**PARK CITY BOARD OF ADJUSTMENT MEETING
SUMMIT COUNTY, UTAH
June 20, 2023**

Subject: 395 Deer Valley Drive
Application: PL-23-05654
Author: Spencer Cawley, Planer II
Date: June 20, 2023
Type of Item: Variance

NOTICE OF BOARD OF ADJUSTMENT ACTION

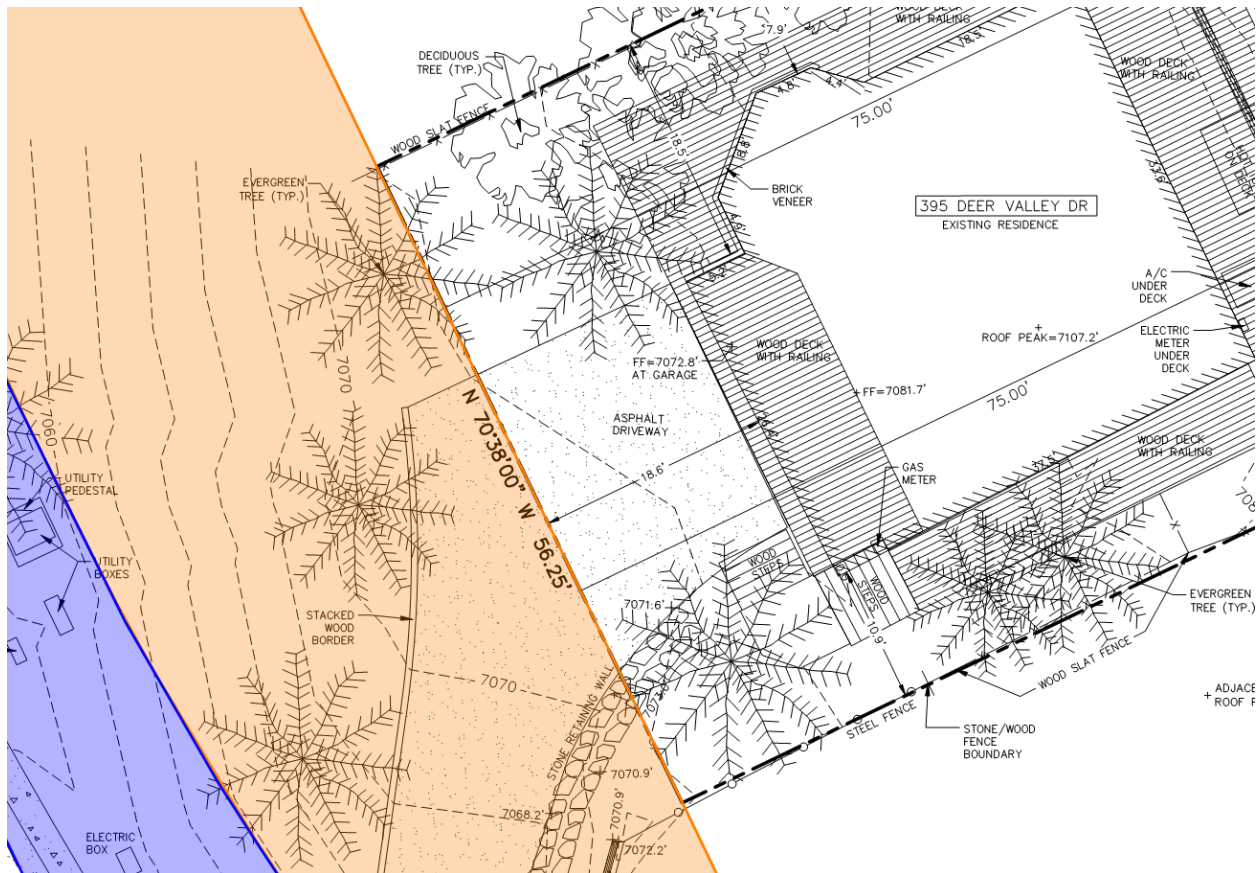
The image below is an excerpt from the Applicant's submittal, showing the existing Single-Family Dwelling and driveway:

The current Single-Family Dwelling is 18.6 feet from the property line, which is also the edge of the historic platted Heber Avenue Right-of-Way (ROW). However, the Dedication Plat of Deer Valley Road Section "A"² is the ROW in use in this area. Subsequently, the Single-Family Dwelling is 51.6 feet from constructed Deer Valley Drive.

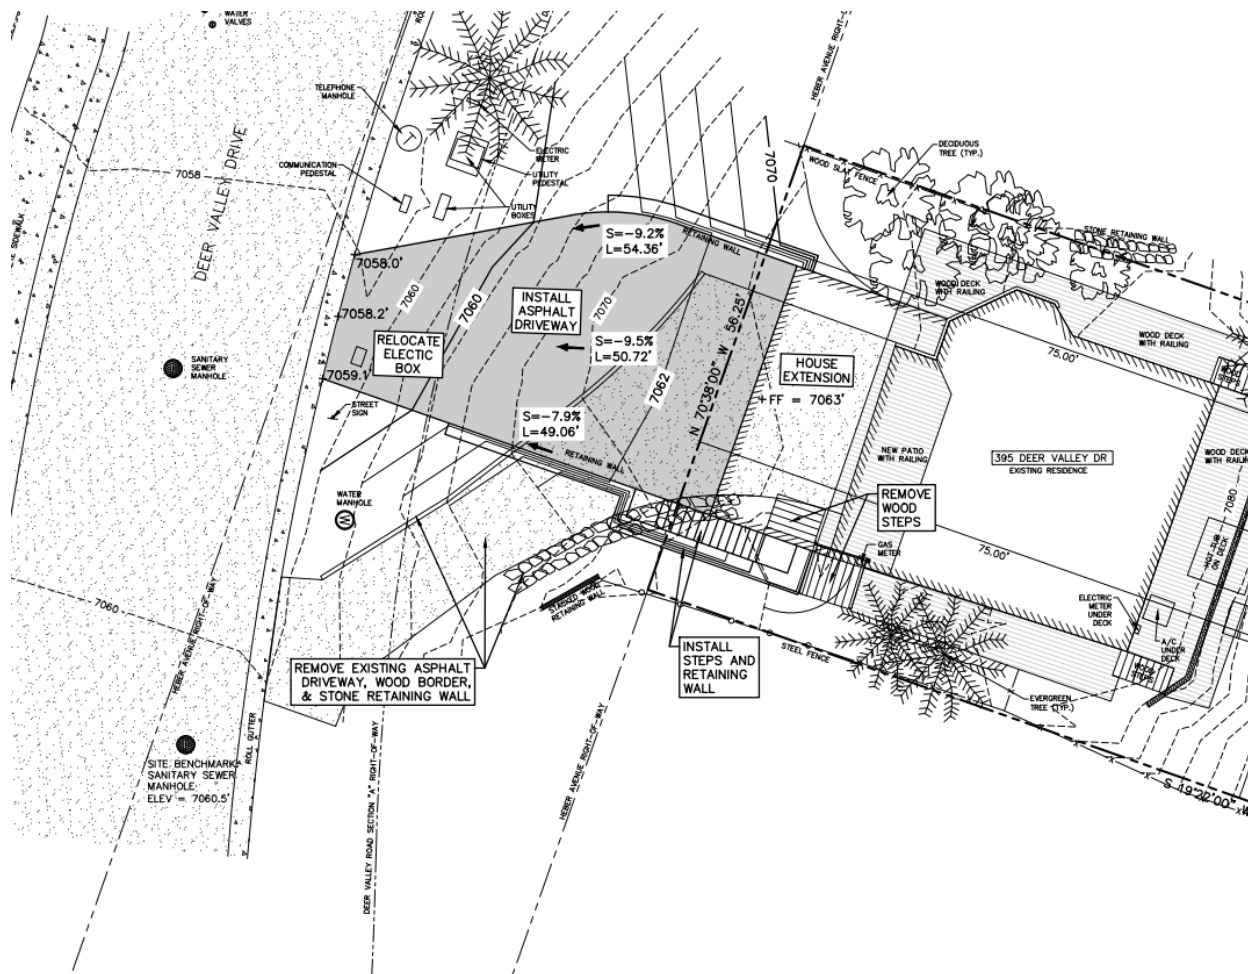
The image below is from the Applicant's submittal and shows the approximate location of the proposed garage and driveway on a site plan of the Property:

(I) The Applicant seeks a Variance from the 20-Foot Residential – 1 (R – 1) Zoning District Front Setback requirements outlined in LMC § 15-2.12-3 Lot and Site Requirements.

The LMC requires a minimum Front Setback of 15 feet, and Front Facing Garages for Single-Family Dwellings must be at least 20 feet from the Front Property Line in the R – 1 Zoning District.⁴ Because of the distance from Deer Valley Drive to the property line – approximately 30 feet at its closest point – the Applicant proposes to reduce the Front Setback from 20 feet to four feet to place the new garage four feet from the property line.

10. The Applicant shall reduce the driveway width from 32 feet to a maximum of 27 feet as outlined in LMC § 15-3-3(H)(1) prior to submitting a Building Permit application.

SITE PLAN
395 DEER VALLEY DRIVE
BLOCK 65, PARK CITY SURVEY

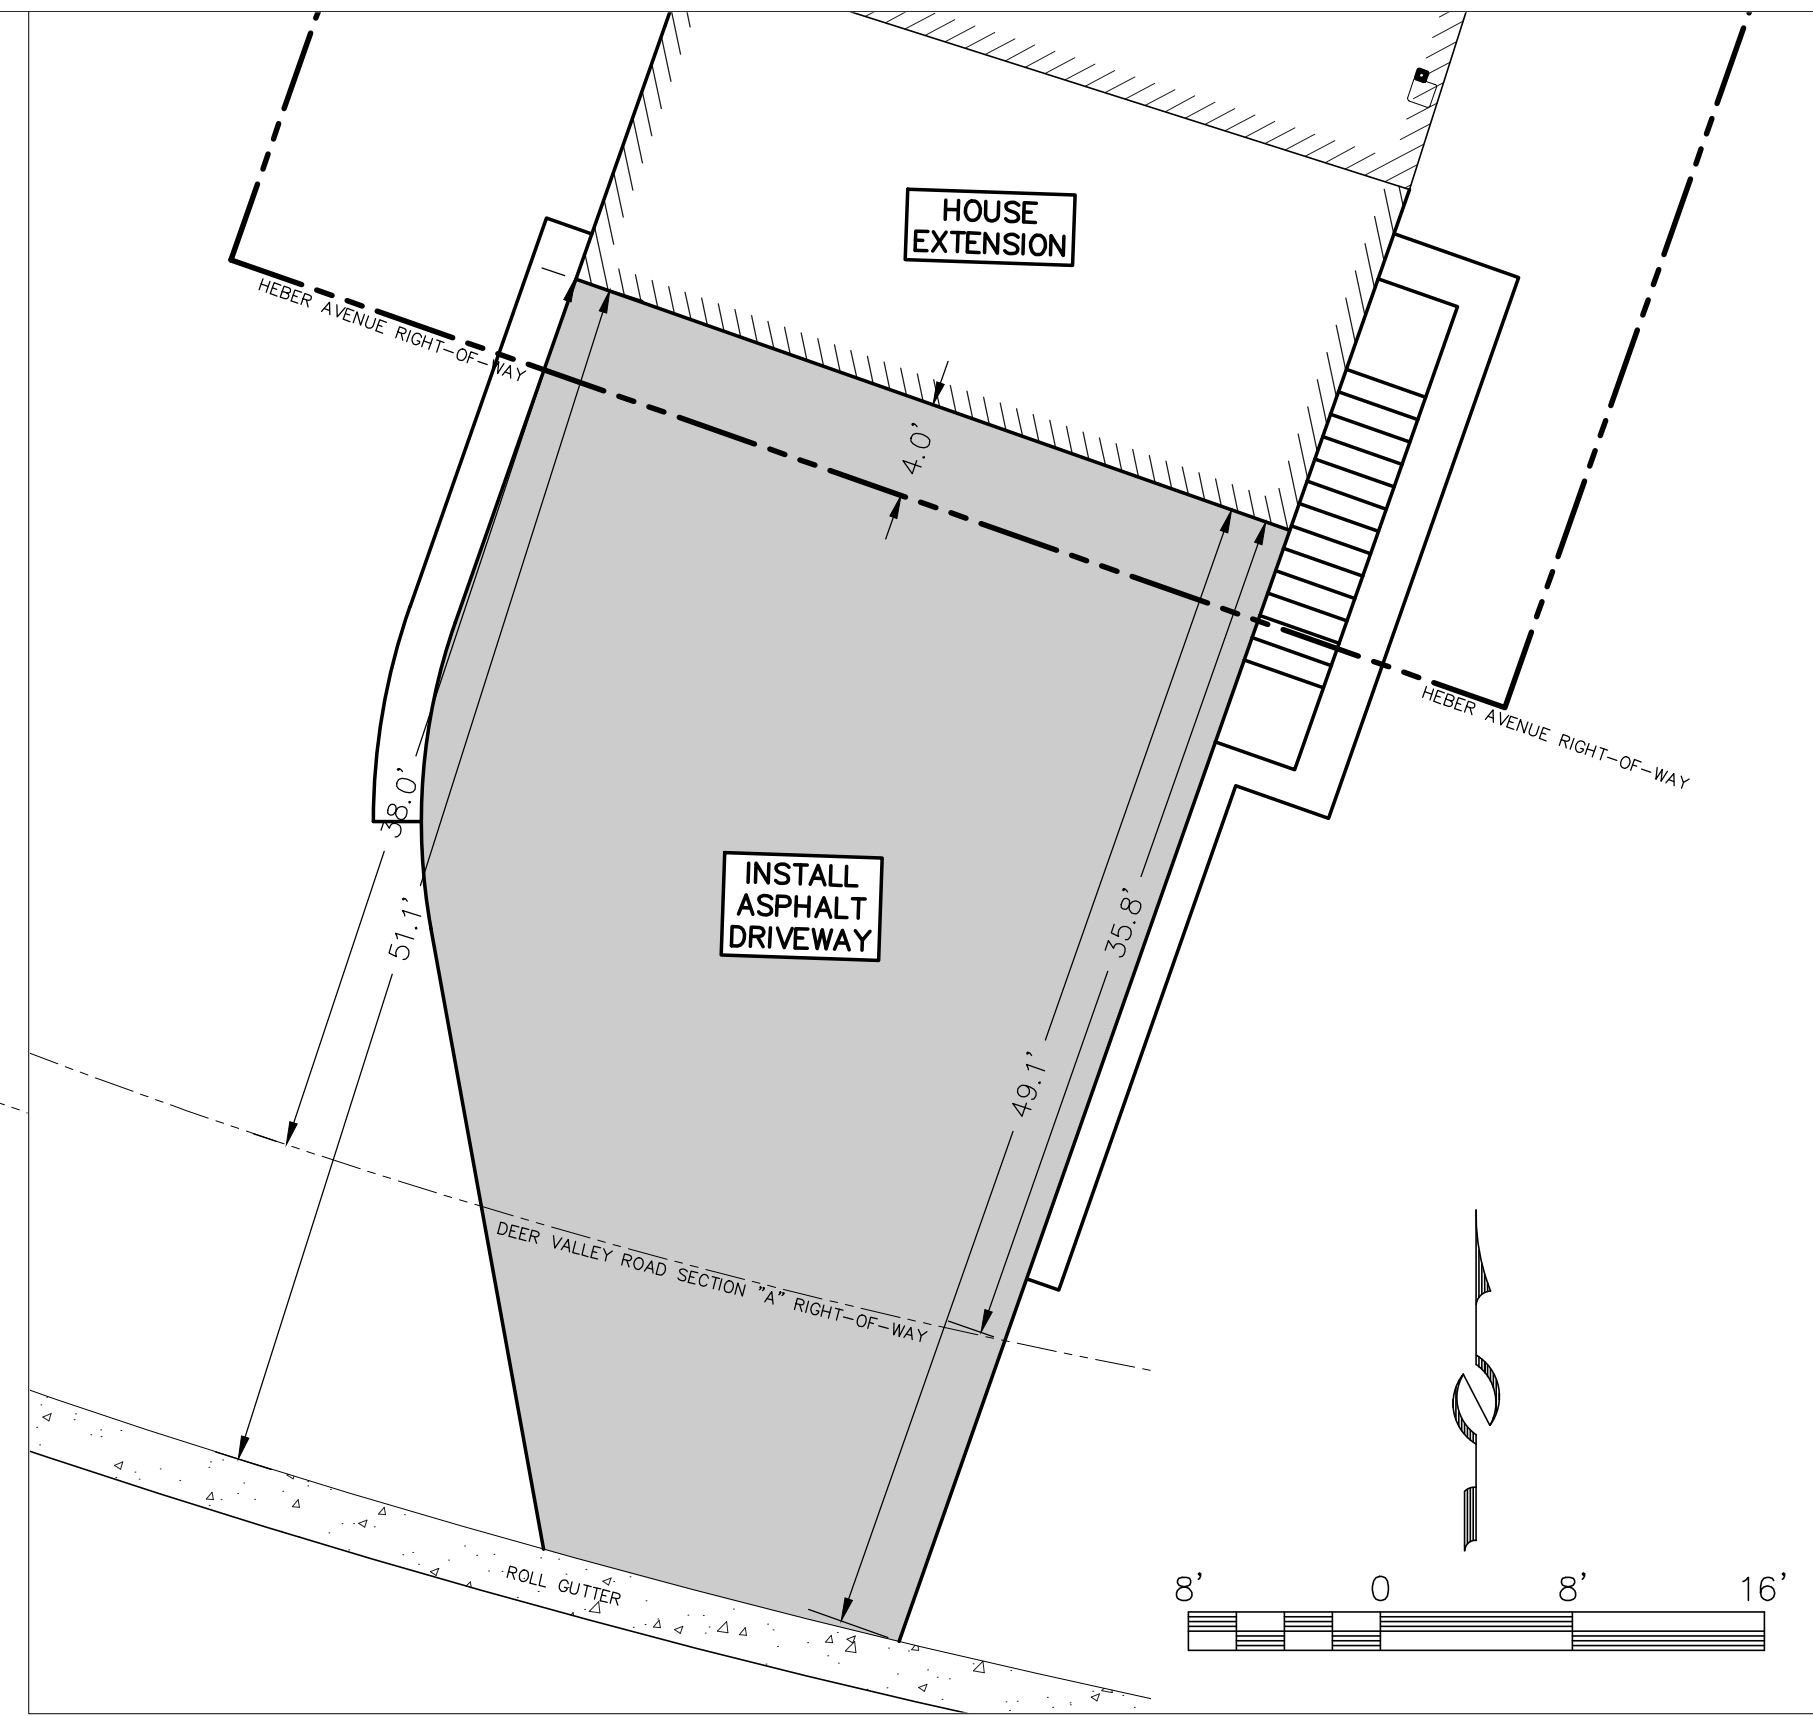
The proposed remodeling of the residence includes adding a new garage in front of the existing house at an elevation lower than the existing garage as well as a redesigned driveway. This Request for Variance proposes a 4-foot setback from the property line for the garage addition. This property is in the Residential (R1) zone, which requires a 20-foot front setback for new front facing garages. The proposed location of the new garage would be an additional 15.8 feet from the Deer Valley Drive right-of-way for a total setback of 35.8 feet at its closest point.

The current driveway has a slope of approximately 19%, which exceeds the maximum of 14% required by the Land Management Code. The new driveway would be in compliance with the LMC at a slope of 9% and will also move the entrance approximately 40 feet down Deer Valley Drive for improved sight distance looking up Deer Valley Drive.
